802.1 maintenance item 0319: Race condition in 802.1Q-2018 between List Config state machine (clause 8.6.9.3) and Cycle Timer state machine (clause 8.6.9.1)

Alon Regev

SEPT 21, 2021

Proposed solution #3

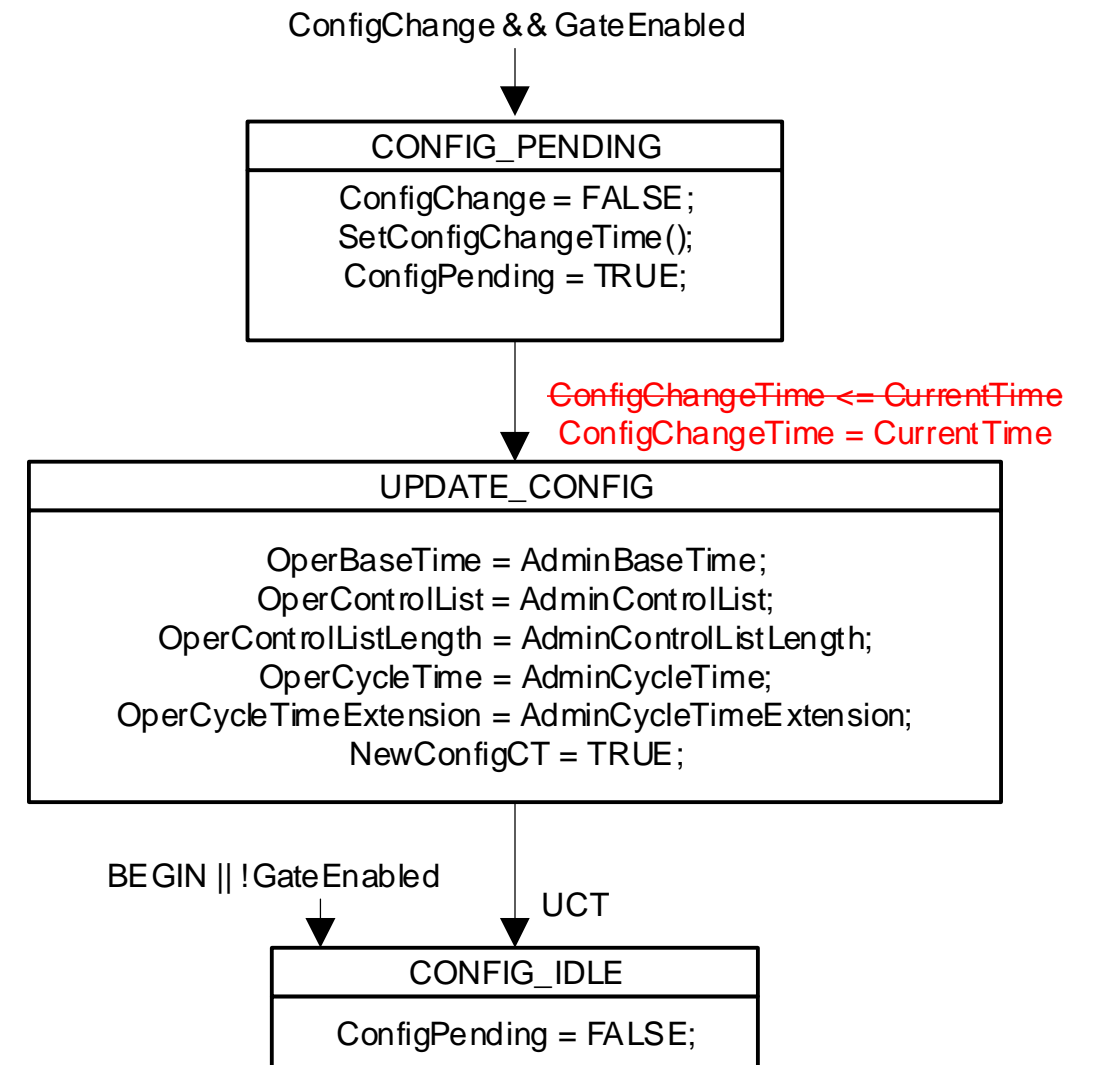
- In the List Config State Machine, change the transition from CONFIG_PENDING to UPDATE_CONFIG to only occur when ConfigChangeTime = CurrentTime
- As SetConfigChangeTime always sets ConfigChangeTime to either the current time or a future time, we can assume that we can transition states exactly at the ConfigChangeTime (when ConfigChangeTime = CurrentTime).
- This is the simplest change and has no other slides or backup materials.
- This doesn't avoid the race condition, but I believe that it leads to both paths in the race condition leading to the same result.

Potential Solution #1 – part 1

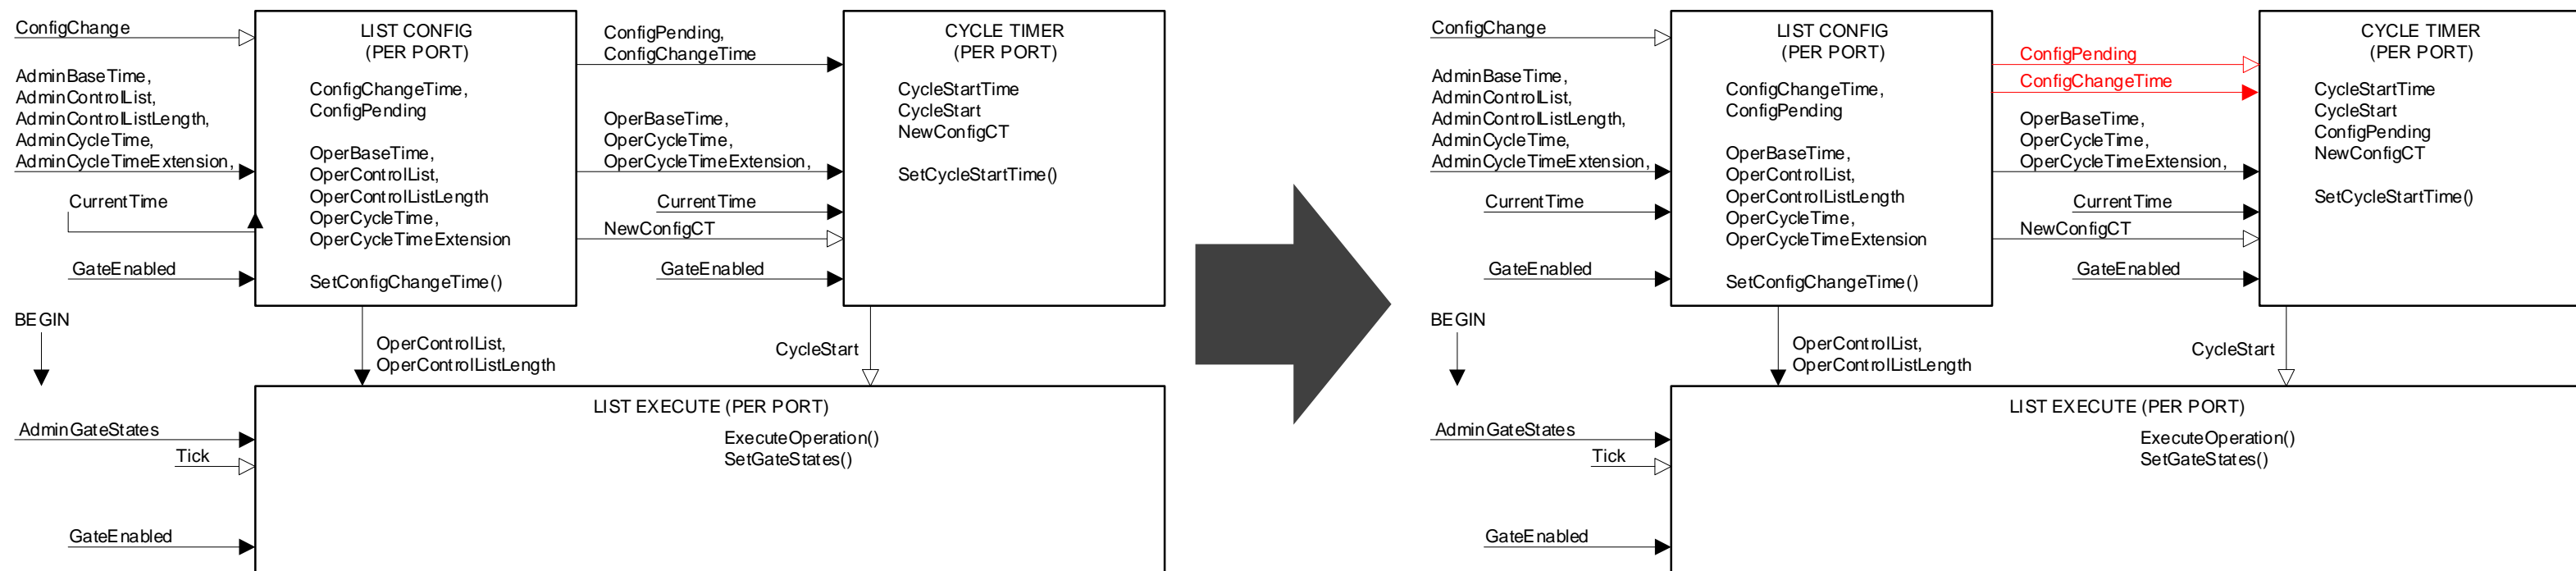
- In Clause 8.6.9.3 , Figure 8-18 (Scheduled traffic state machines—overview and relationships):
 - On the arrow with the text “ConfigPending, ConfigChangeTime”, change the text to “ConfigPending” and change the arrow shape to be one with the outline only (no fill).
 - Add an arrow underneath the ConfigPendingArrow starting at the “LIST CONFIG” box and ending at the “CYCLE TIMER” box with the text “ConfigChangeTime”, no arrow at the LIST CONFIG SIDE, and a filled in arrow at the CYCLE TIMER side.

Proposed solution #1 – part 2

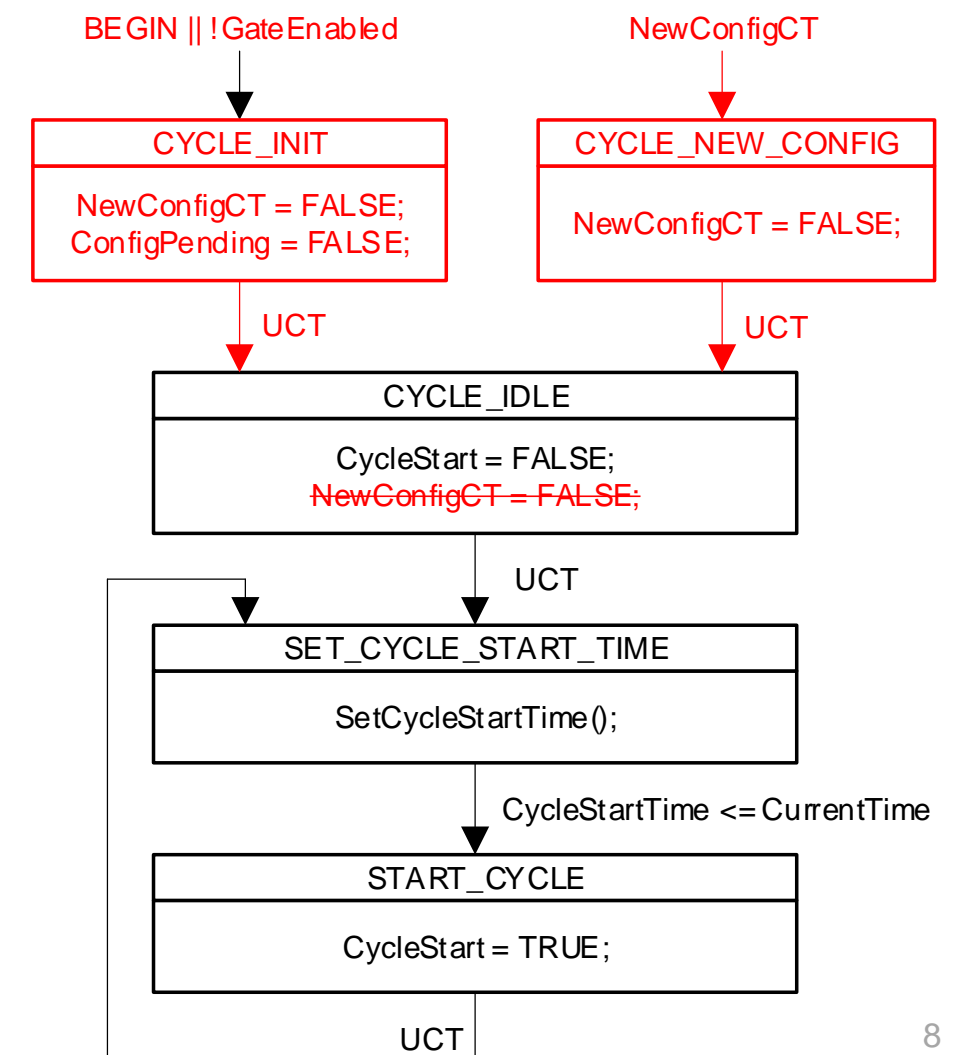
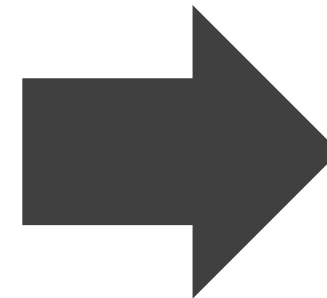
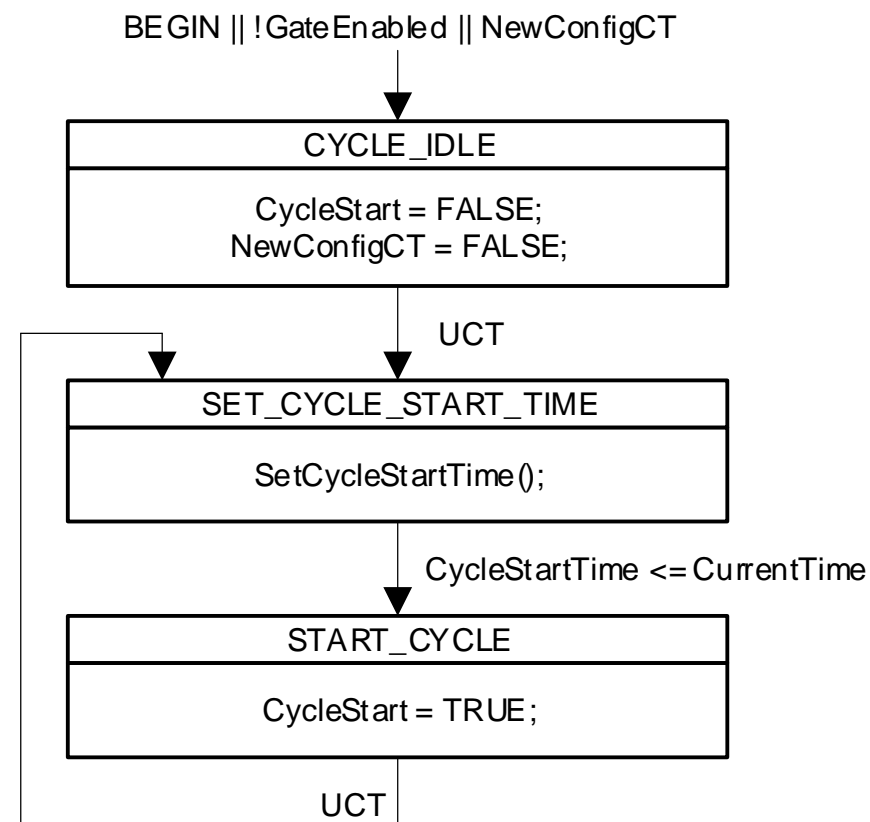
- In Clause 8.6.9.1 , Figure 8-19 (Cycle Timer State Machine):
 - Remove the global transition from “BEGIN || !GateEnabled || NewConfigCT” to CYCLE_IDLE

- Add a new state named “CYCLE_INIT”
 - This state will contain the lines “NewConfigCT = FALSE;” and “ConfigPending = FALSE;”
 - Add a global transition from “BEGIN || !GateEnabled” to the new CYCLE_INIT state

- Add a new state named “CYCLE_NEW_CONFIG”
 - This state will contain the line “NewConfigCT = FALSE;”
 - Add a global transition from “NewConfigCT” to the new CYCLE_INIT state

- Add an UCT transition from the CYCLE_INIT state to the CYCLE_IDLE state
 - Add an UCT transition from the CYCLE_NEW_CONFIG state to the CYCLE_IDLE state

- Add an UCT transition from the CYCLE_IDLE state to the SET_CYCLE_START_TIME state
 - Add an UCT transition from the SET_CYCLE_START_TIME state to the START_CYCLE state

- Add an UCT transition from the START_CYCLE state to the SET_CYCLE_START_TIME state
 - Remove the line “NewConfigCT = FALSE;” from the CYCLE_IDLE state

Potential Solution #1 – part 4

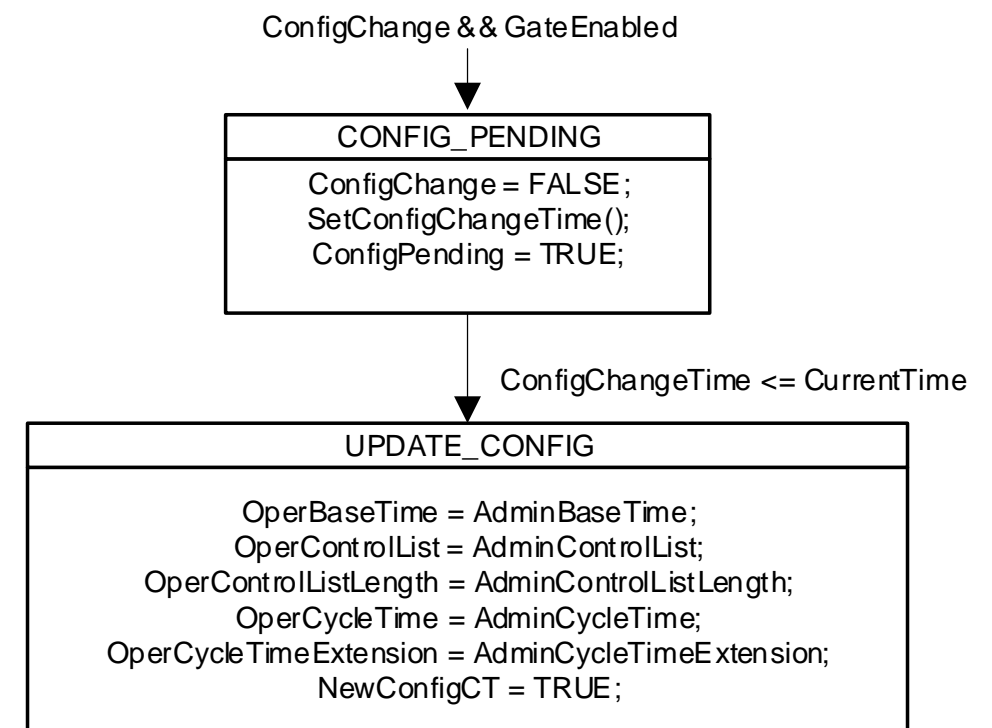
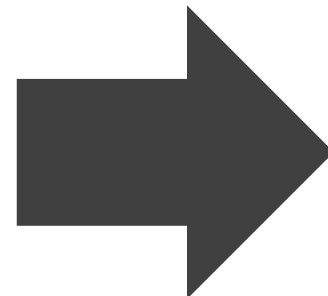
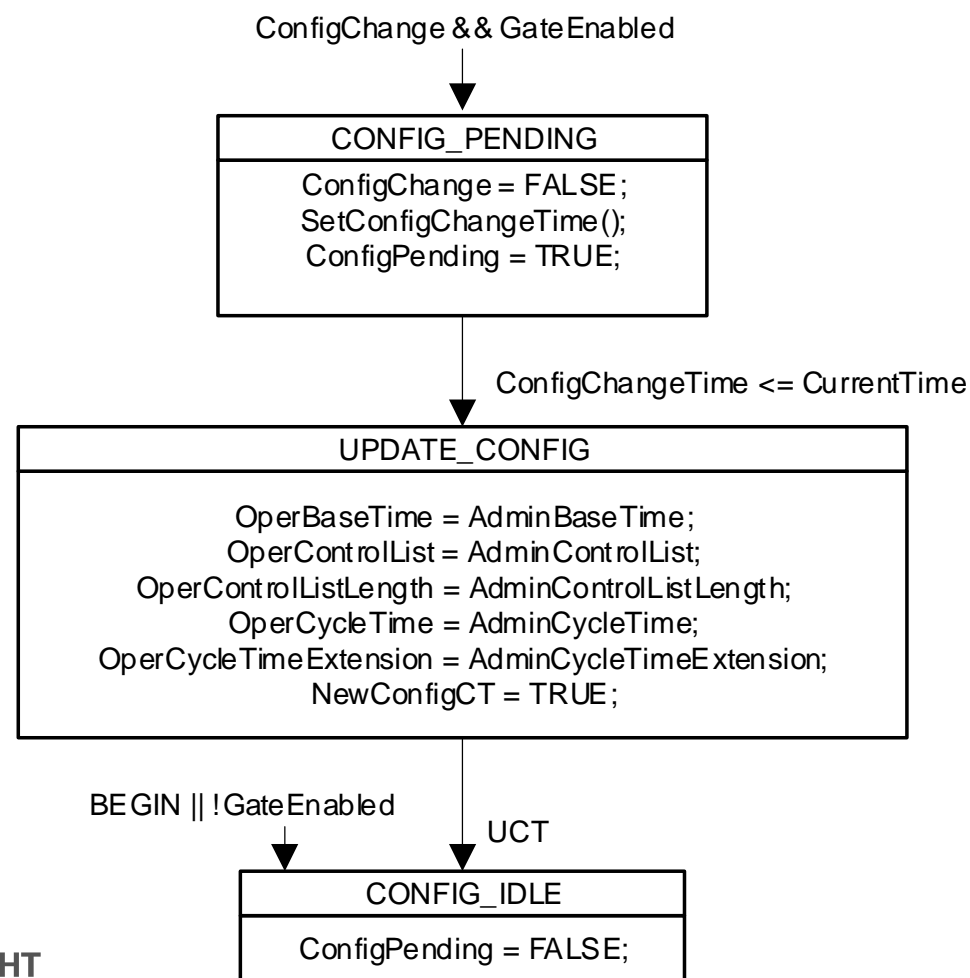
- In Clause 8.6.9.3 , Figure 8-21 (List Config State Machine):
 - Remove the CONFIG_IDLE state and all transitions to it.

Proposed solution #2 – part 1

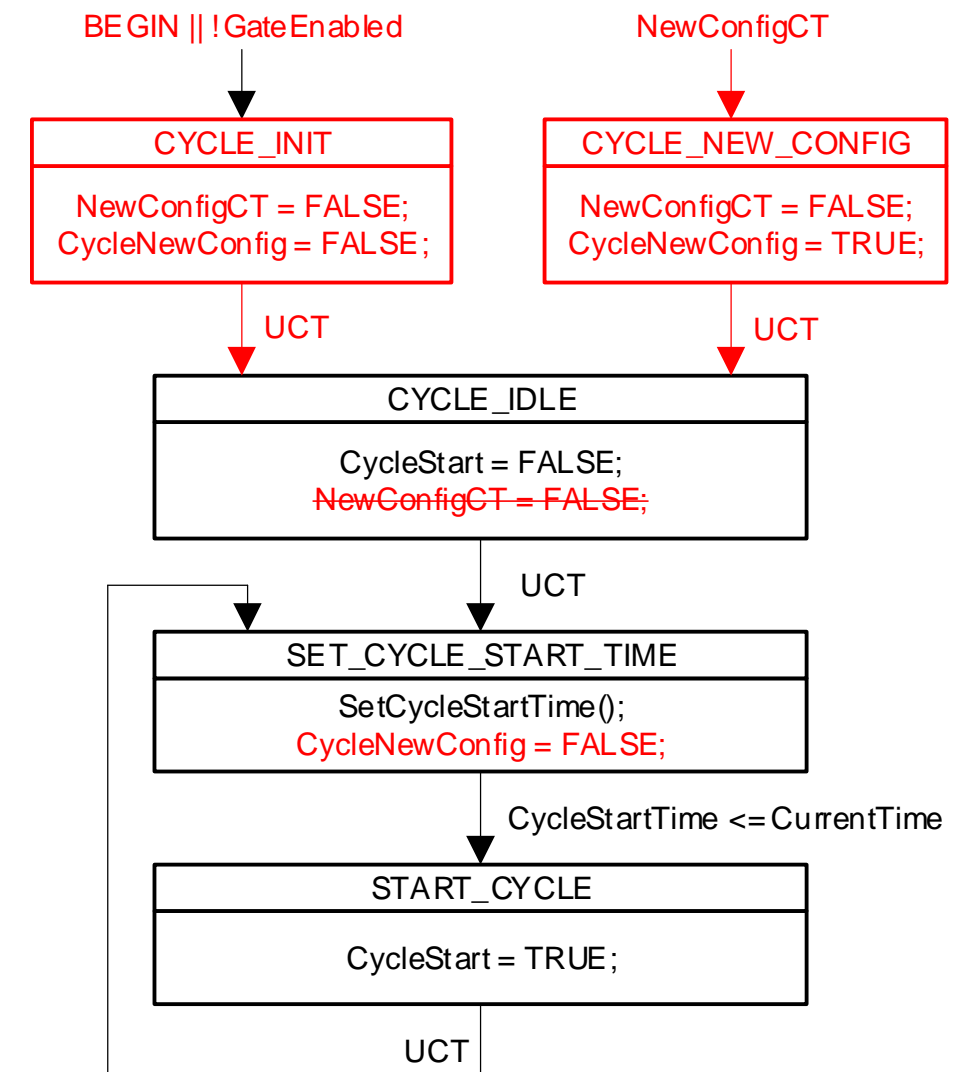
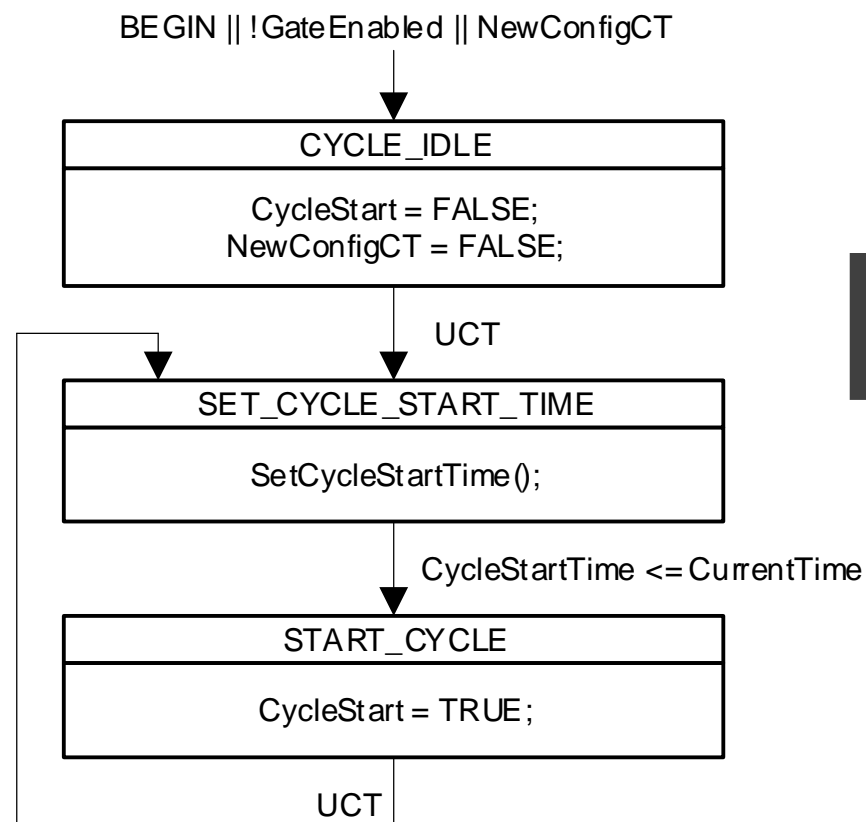
- In Clause 8.6.9.1 , Figure 8-19 (Cycle Timer State Machine):
 - Remove the global transition from “BEGIN || !GateEnabled || NewConfigCT” to CYCLE_IDLE
 - Add a new state named “CYCLE_INIT”
 - This state will contain the “NewConfigCT = FALSE;” and “CycleNewConfig = FALSE;”
 - Add a global transition from “BEGIN || !GateEnabled” to the new CYCLE_INIT state
 - Add a new state named “CYCLE_NEW_CONFIG”
 - This state will contain the “NewConfigCT = FALSE;” and “CycleNewConfig = TRUE;”
 - Add a global transition from “NewConfigCT” to the new CYCLE_INIT state
 - Add an UCT transition from the CYCLE_INIT state to the CYCLE_IDLE state
 - Add an UCT transition from the CYCLE_NEW_CONFIG state to the CYCLE_IDLE state
 - Remove the line “NewConfigCT = FALSE;” from the CYCLE_IDLE state
 - In the SET_CYCLE_START_TIME, after “SetCycleStartTime()” add a new line containing “CycleNewConfig = FALSE;”

Proposed solution #2 – part 2

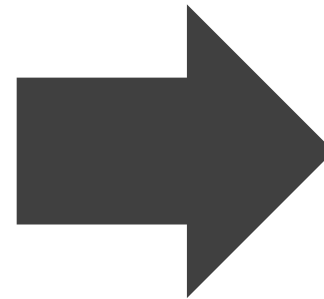
- In Clause 8.6.9.1.1 (SetCycleStartTime() procedure)
 - Replace each occurrence of “ConfigPending = FALSE” with “(ConfigPending = FALSE) and (CycleNewConfig = FALSE)”
 - Replace each occurrence of “ConfigPending = TRUE” with “((ConfigPending = TRUE) or (CycleNewConfig = TRUE))”

- a) If:
(ConfigPending = FALSE) and (CycleNewConfig = FALSE), and
OperBaseTime >= CurrentTime
(i.e., OperBaseTime specifies the current time or a future time)
Then:
CycleStartTime = OperBaseTime.

- a) If:
(ConfigPending = FALSE) and (CycleNewConfig = FALSE), and
OperBaseTime < CurrentTime
(i.e., OperBaseTime specifies a time in the past)
Then:
CycleStartTime = (OperBaseTime + N*OperCycleTime)
where N is the smallest integer for which the relation:
CycleStartTime >= CurrentTime
would be TRUE.

- a) If:
((ConfigPending = TRUE) or (CycleNewConfig = TRUE)), and
ConfigChangeTime > (CurrentTime + OperCycleTime + OperCycleTimeExtension)
Then:
CycleStartTime = (OperBaseTime + N*OperCycleTime)
where N is the smallest integer for which the relation:
CycleStartTime >= CurrentTime
would be TRUE.

- a) If:
((ConfigPending = TRUE) or (CycleNewConfig = TRUE)), and
ConfigChangeTime <= (CurrentTime + OperCycleTime + OperCycleTimeExtension)
Then:
CycleStartTime = ConfigChangeTime
